# LACHLAN'S LINE LOT 110

## RESIDENTIAL APARTMENT BUILDING DEVELOPMENT APPLICATION - ALTERATIONS & ADDITIONS

5 HALIFAX STREET,  
MACQUARIE PARK

**SHEET TITLE**  
SECTION 2

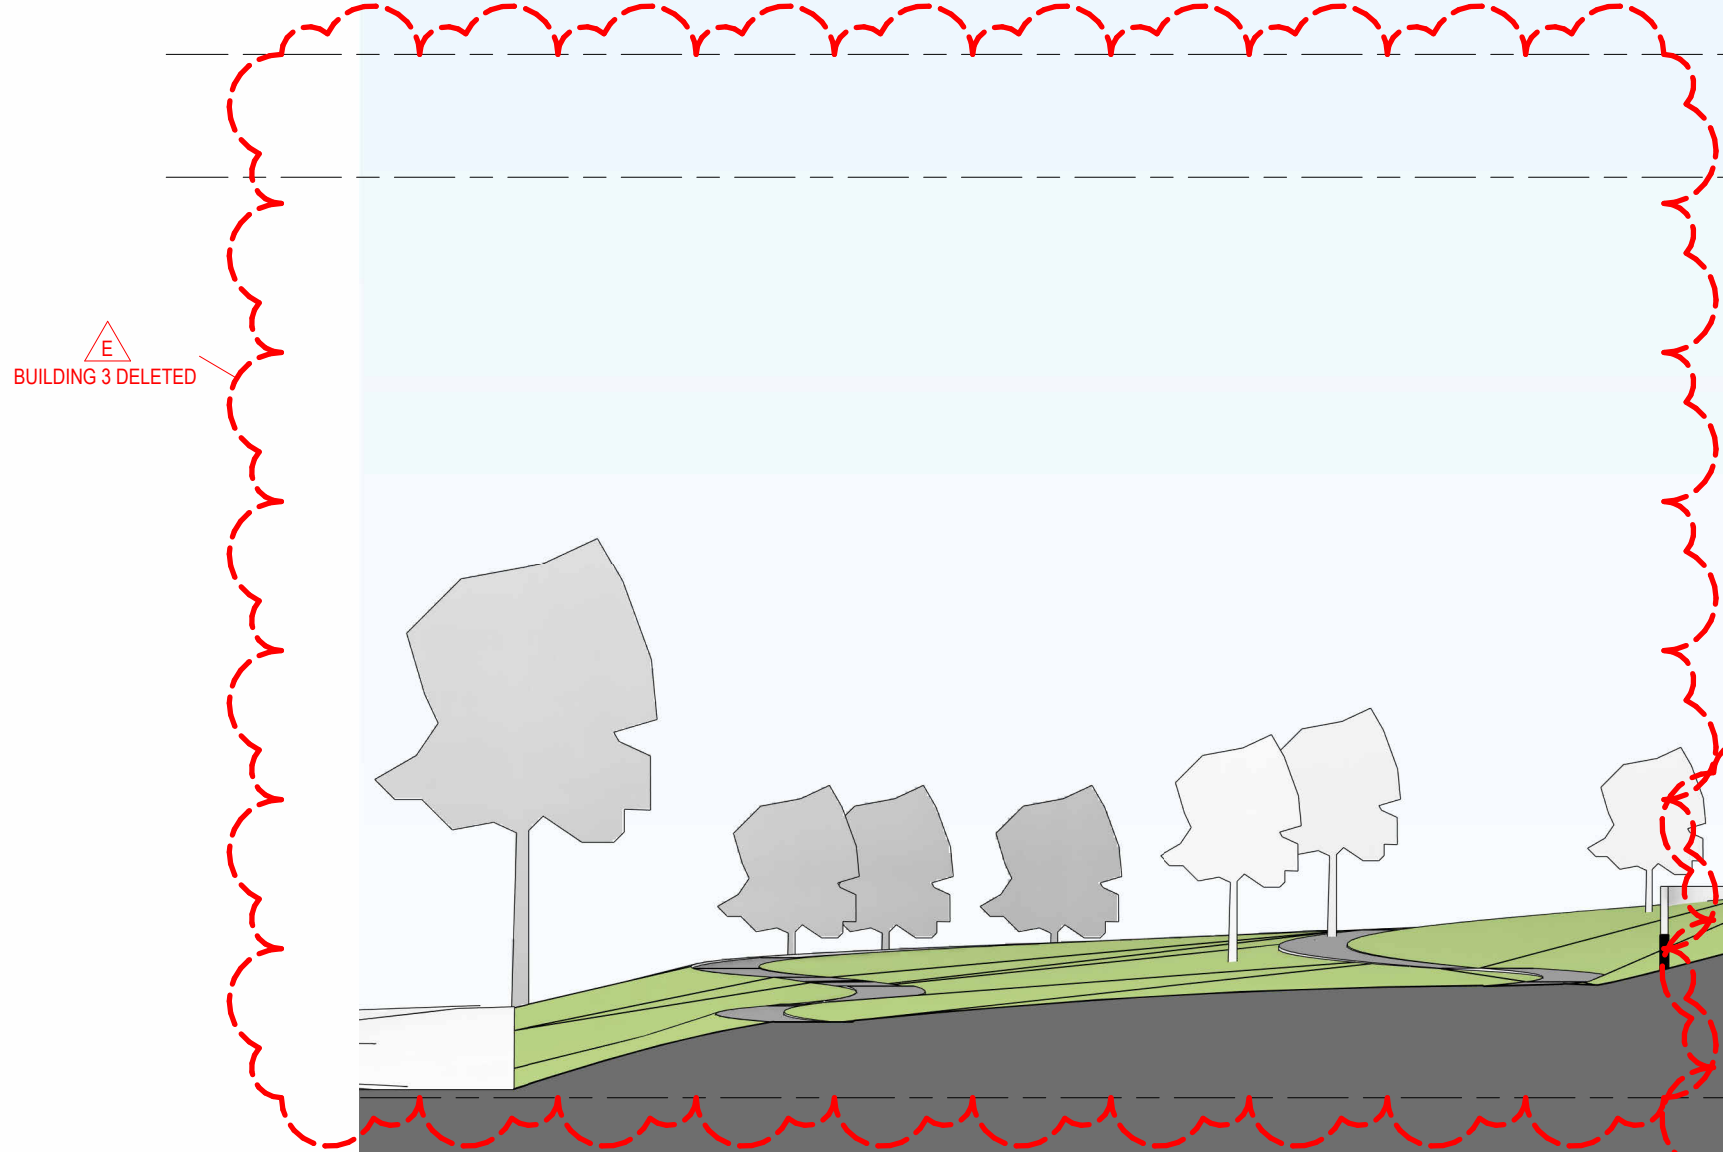
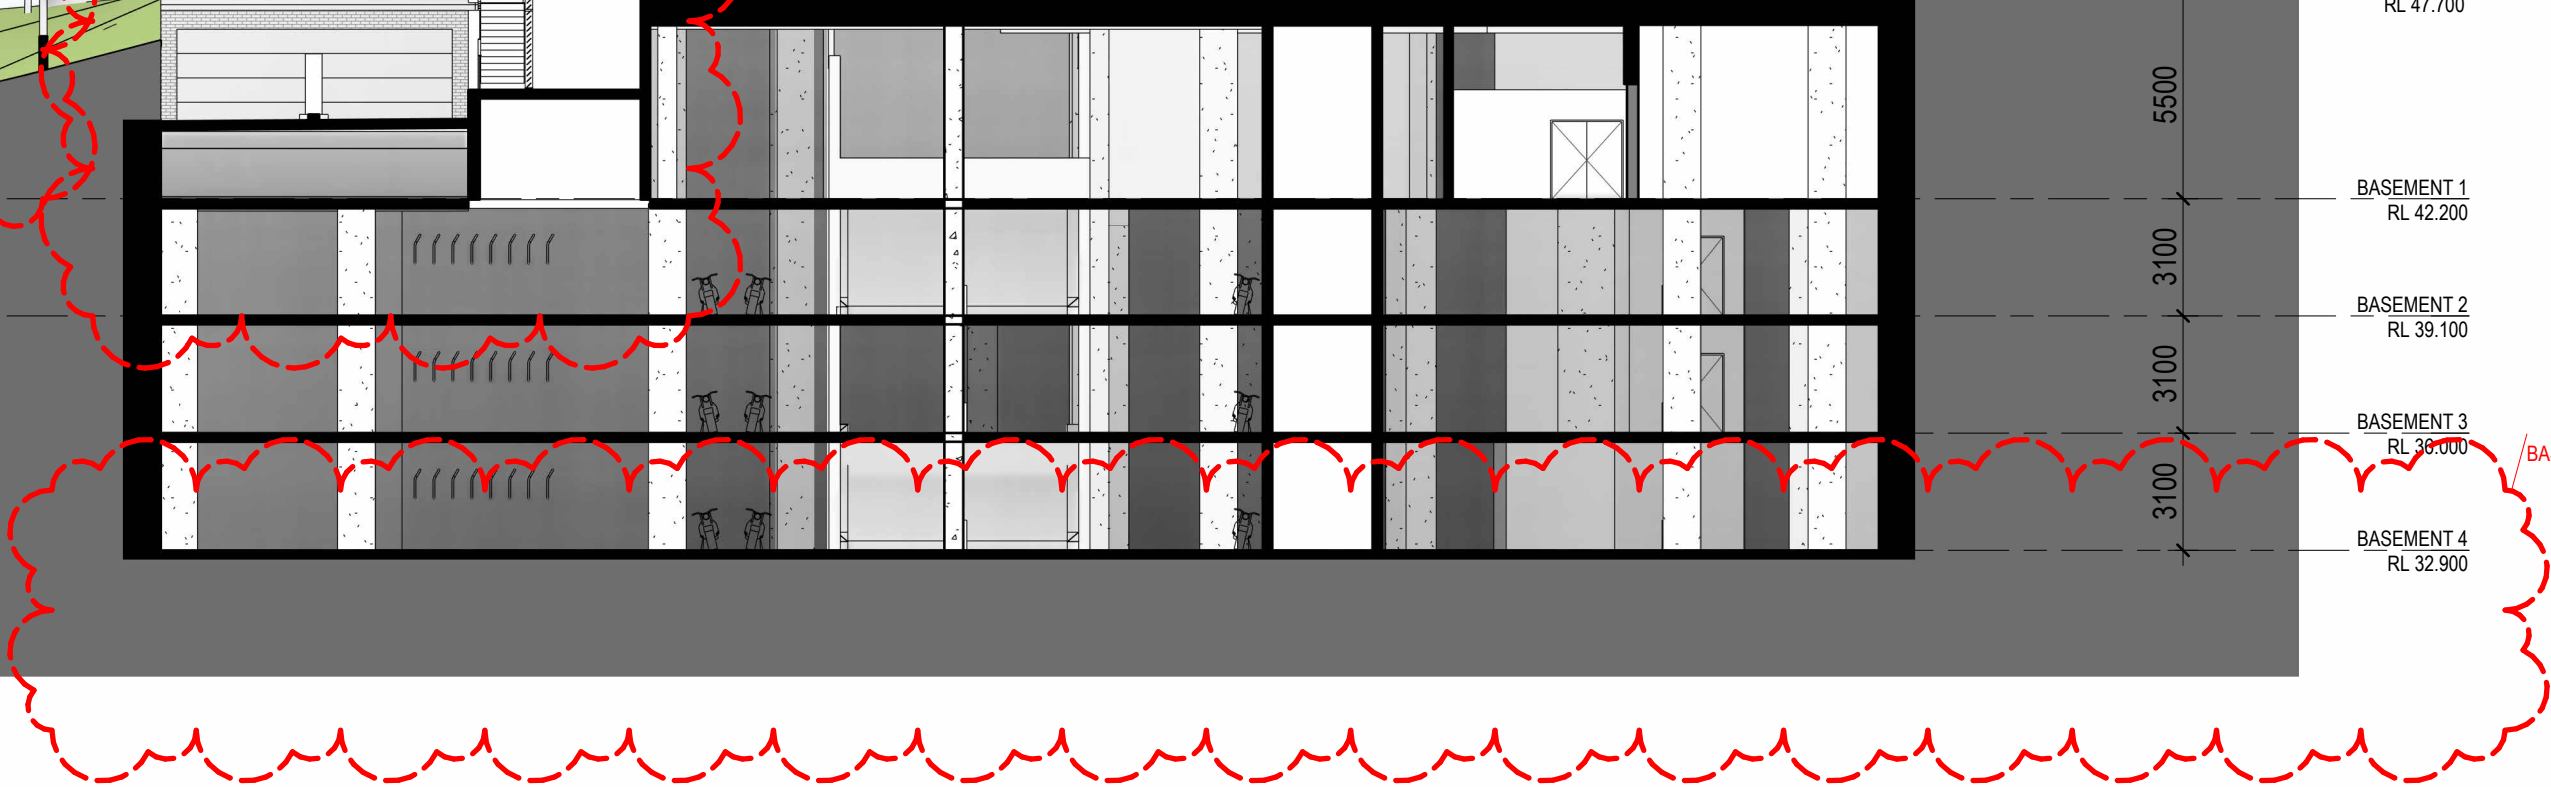
BUILDING 3 DELETED

BUILDING 2  
MAX HEIGHT 24.53 m

L30 ADDED

BASEMENT 5 DELETED

**SHEET TITLE**  
SOLAR ACCESS  
DIAGRAMS - SHEET 2

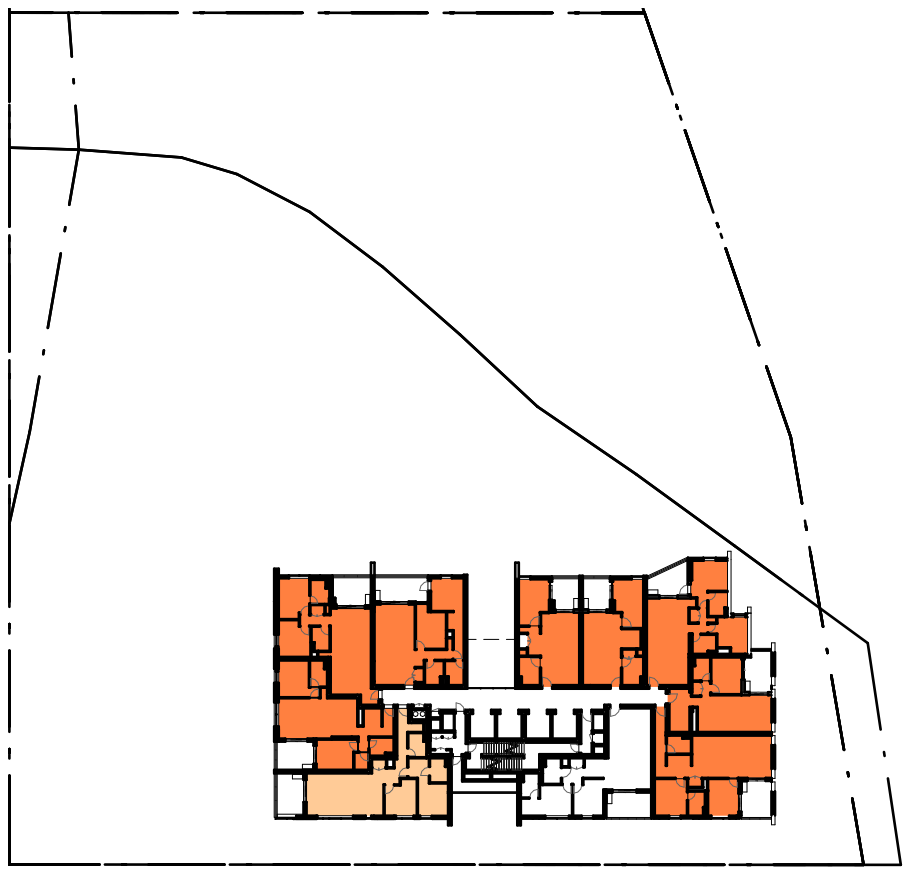
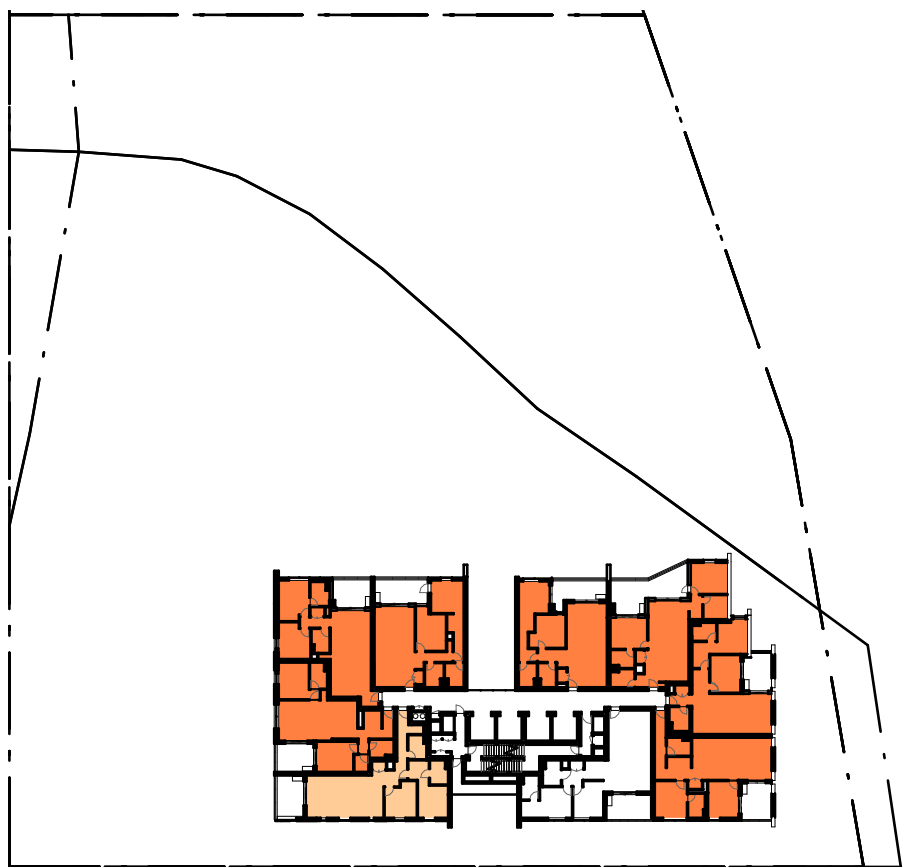
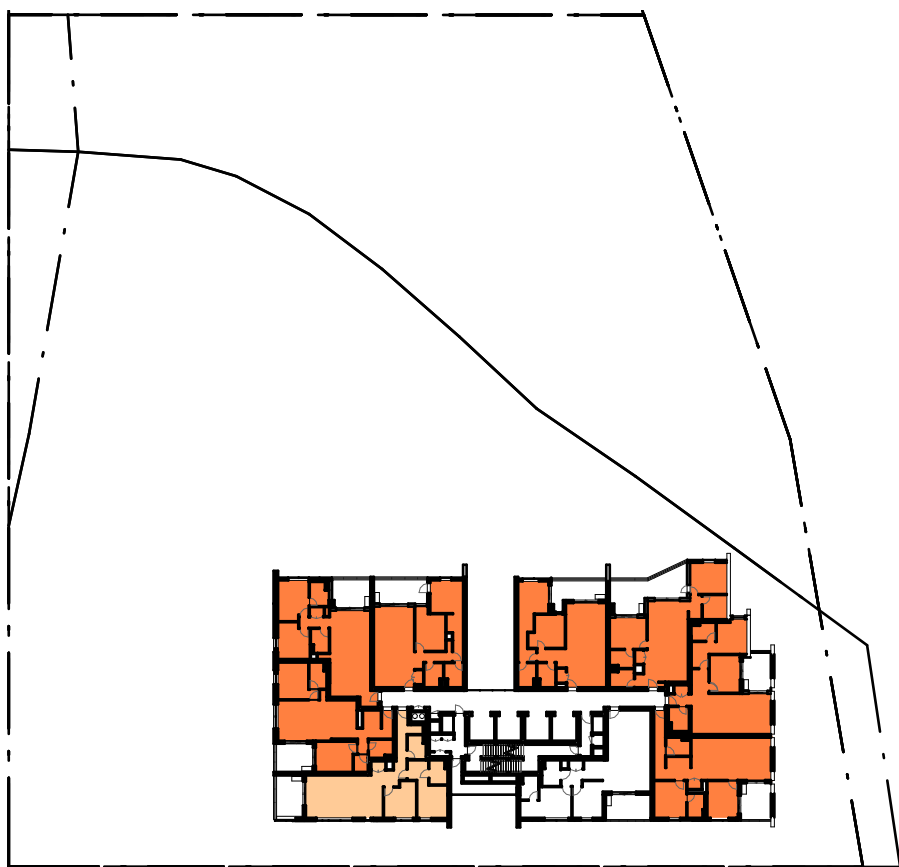
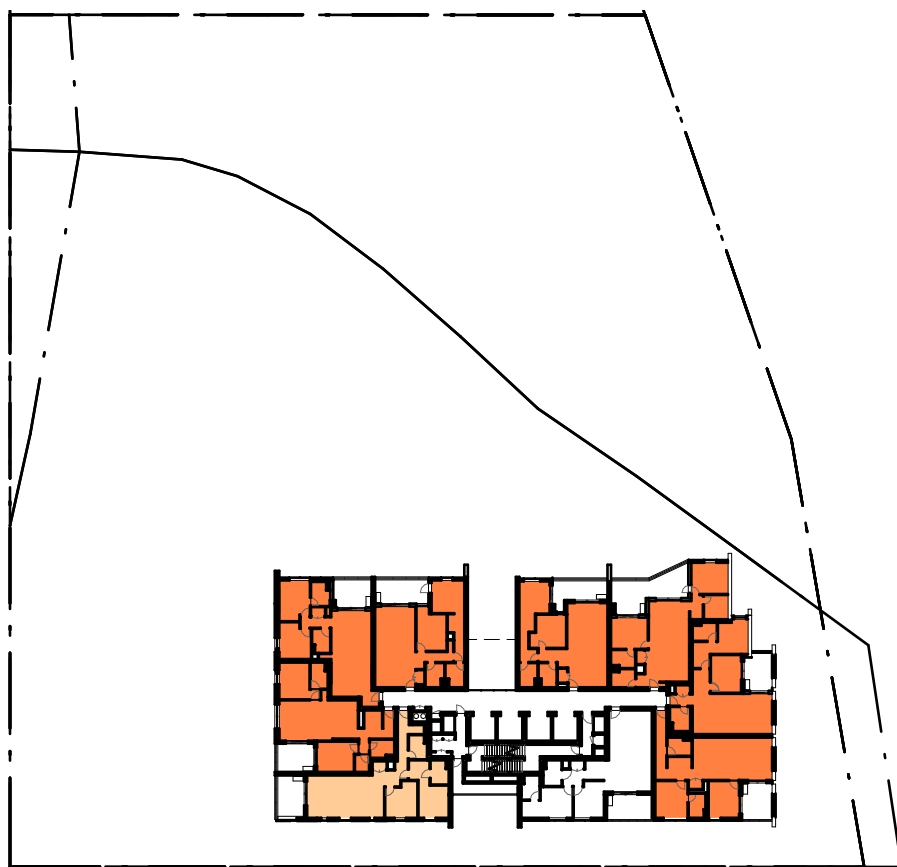
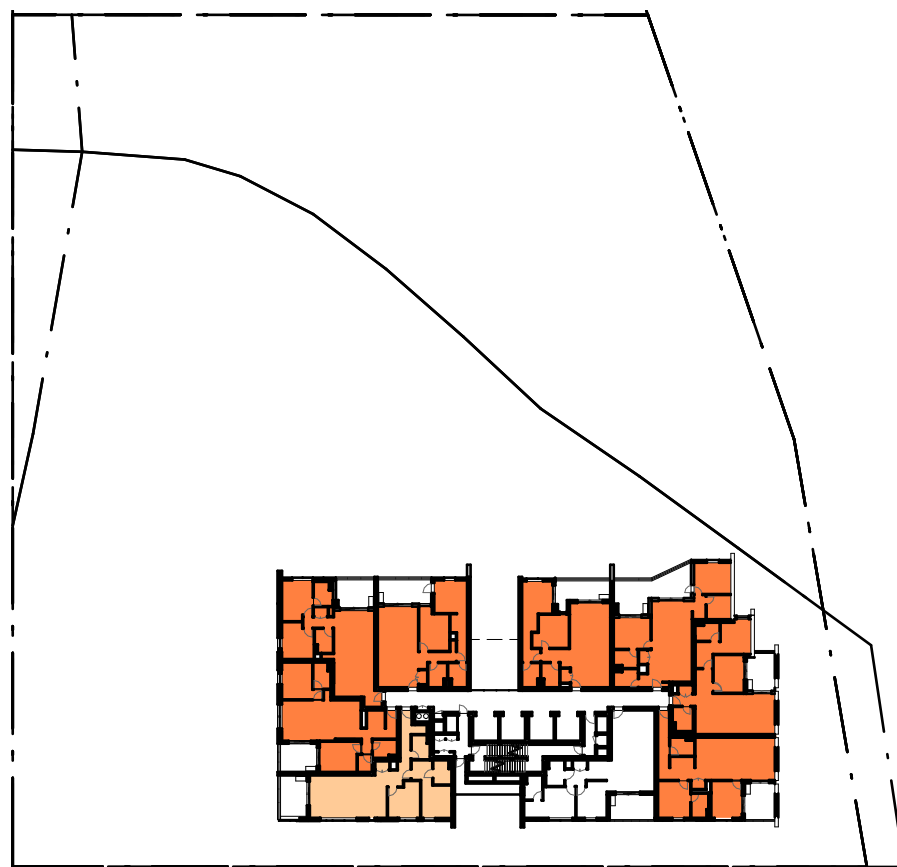
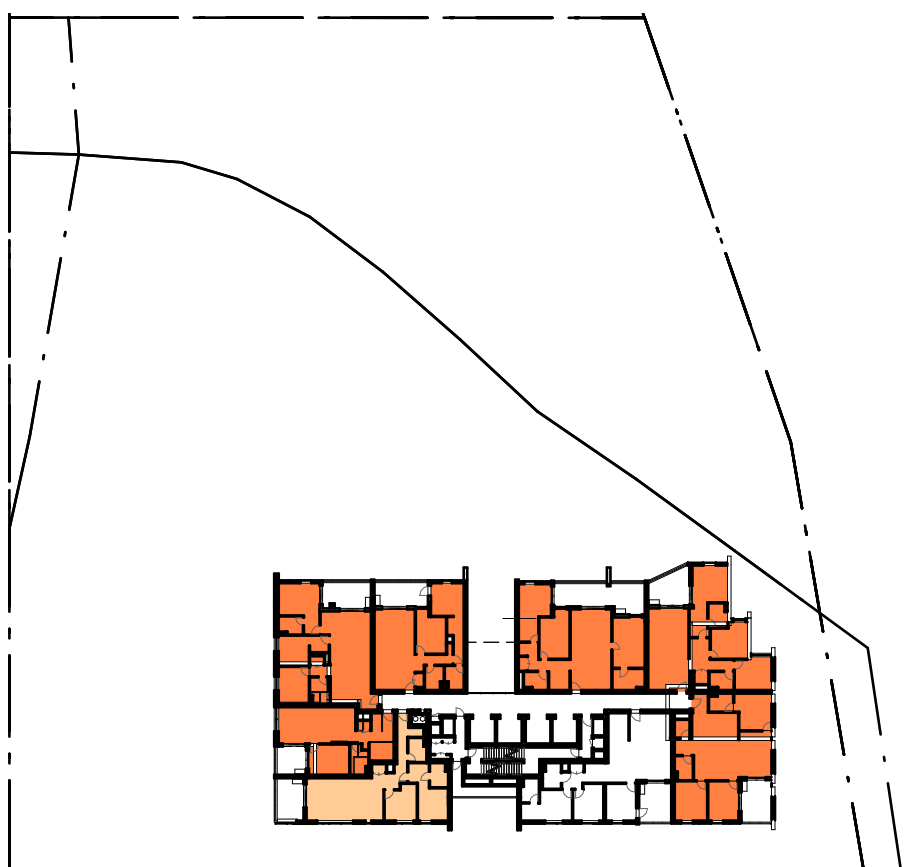
FLOOR PLANS REVISED;  
BUILDING 3 DELETED; L30  
ADDED
